SUBJECT: ADDENDUM NO. 1 TO THE BIDDING DOCUMENTS FOR

VRNTL-20-B-04 VILLAGE OF RANTOUL - MULTIPLE ROOF REPLACEMENT

Addendum No.1

ROOF EDGE TRIM DETAIL 1

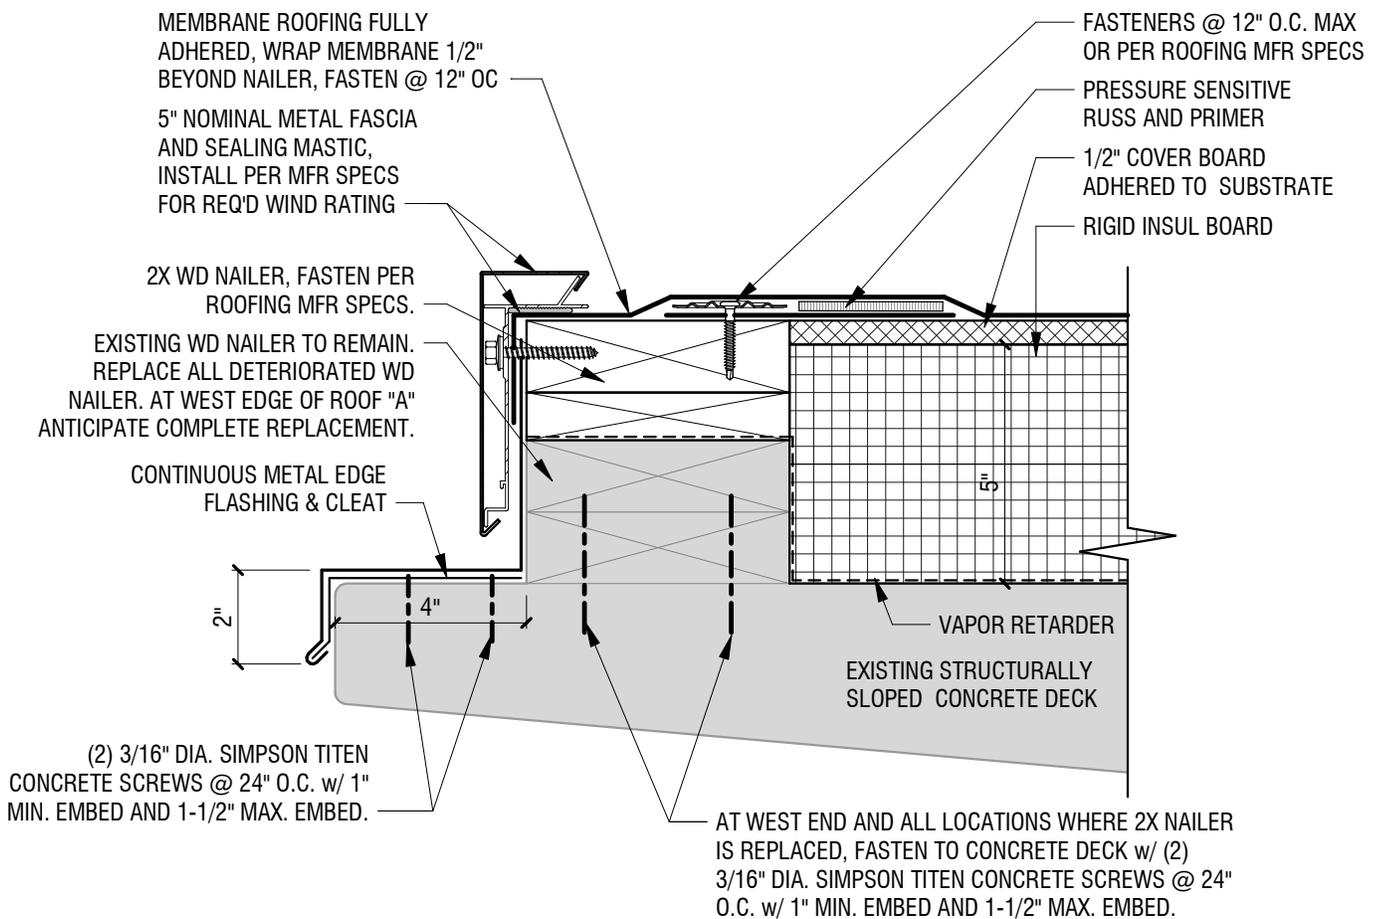
4. Sheet A101
 - a. ~~DELETE~~- General Note "G"
5. Sheet A102
 - a. ~~DELETE~~- General Note "G"
6. Sheet A201
 - a. **REVISE** Detail 1/A201 See attached sheet AD-1
